PLAN COMMISSION
August 3, 2016
Village Hall
125 Depot Street
5:00 p.m.

1. Call to order - Roll Call
2. Statement of Public Notice
3. Approve Minutes of July 11, 2016 – *pg 1*
4. Site Plan – JWR Inc., Mechanical and Screening – 322 N. Watertown St. – *pgs 2-9*
5. Next Meeting – September 12, 2016 – 5:00 p.m.
6. Adjourn

RE: Site Plan Review at 322 Watertown Street

Re: JWR Inc. Enclosure Review
Site Plan Review
MSA PN 05114017

DESIGN SOUND LEVELS

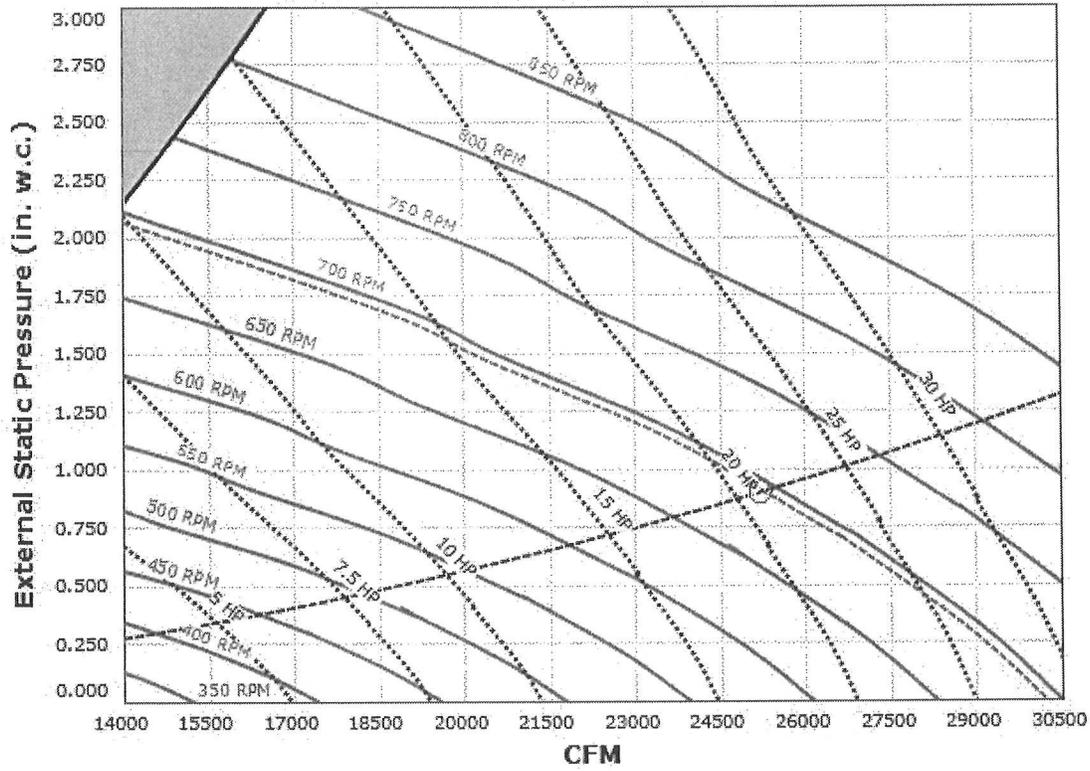
The Village noise requirements will protect neighboring properties from noise levels if noise exceeds the allowed limits.

However, I believe that the choice of equipment, combined with its location within the proposed enclosure, will keep noise levels well under the permitted limits.

1 ENLARGED AREA SITE PLAN
1" = 10'-0"

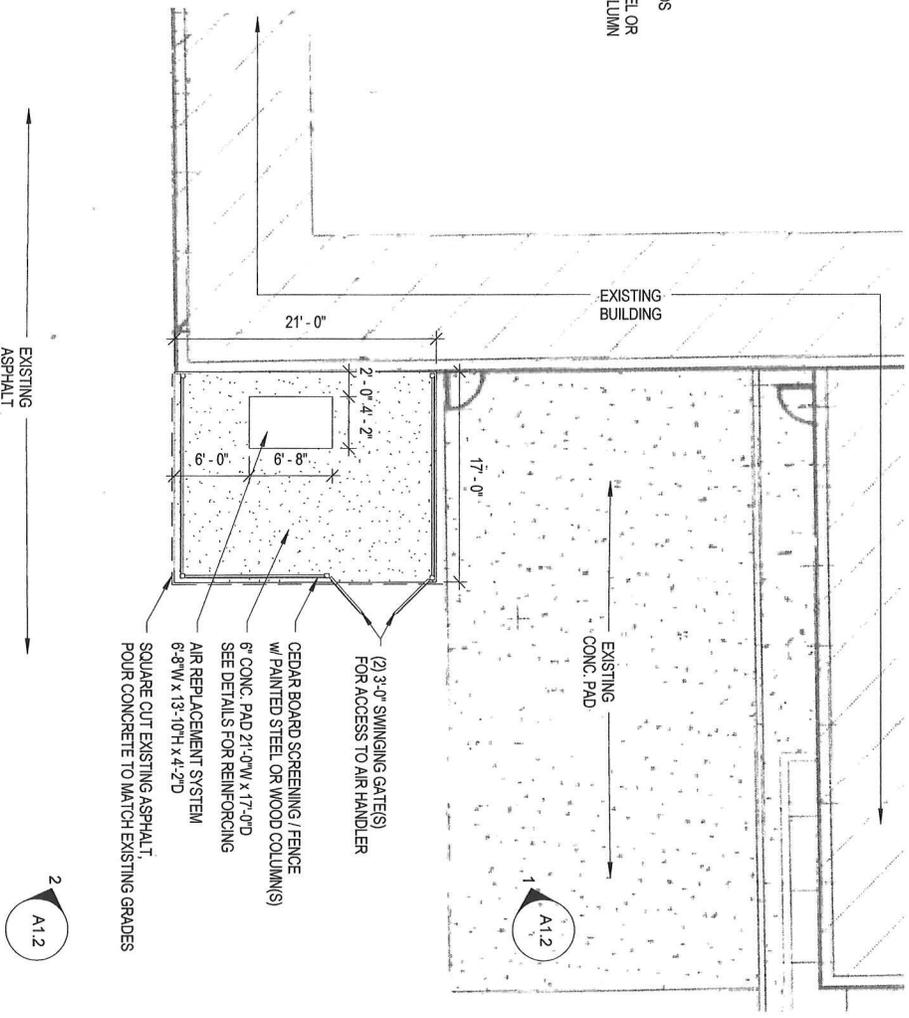
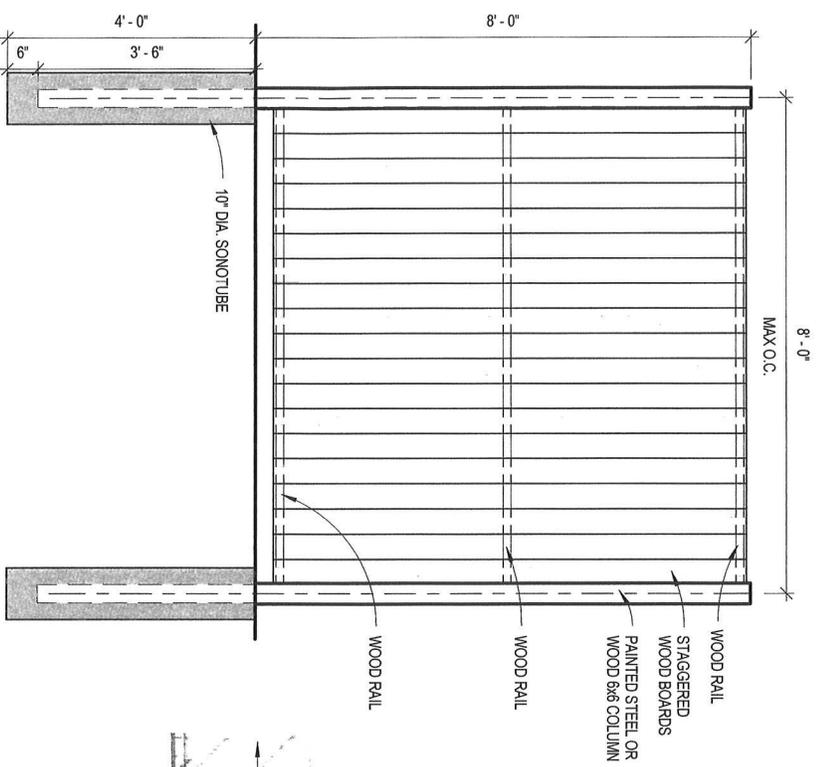
1. The enclosure will cause the loss of one tree. If possible relocate this tree within the property.
2. The enclosure area will be over and affect one of the current drain spouts from the roof. I am not sure how the drain spout is connected beneath the ground but with the pilings and such, this should be addressed to not interfere with the current drainage. I cannot tell from the drawings if the vent system interferes with the drain coming from the roof.
3. The area will drain away from the building down the parking lot as the current water drains across the pavement.
4. I am not aware of any environmental concerns with the air makeup units for the areas adjacent to the enclosure.

Attached is my review letter on the JWR enclosure. Overall it meets requirements for the fencing and the such. I do not know much about any environmental hazards but did some looking online at some of these units and they are environmentally friendly. The only item that will have to be addressed or noted is the drain spout as to whether that will need to be moved or the such from the roof. I am also not sure how that connects as in if there is a trunk system along the building that the drain spouts feed to or what and with the foundations for the fence this may have to be reviewed.

Down spout is approximately 14'6" from the south corner and will probably not interfere with the downspout if it does it will be elbowed back to the current storm sewer it drains into.

Final design of the slab will take into account location of this storm sewer and the weight it receives from the equipment.

All surfaces in this area sheet flow.
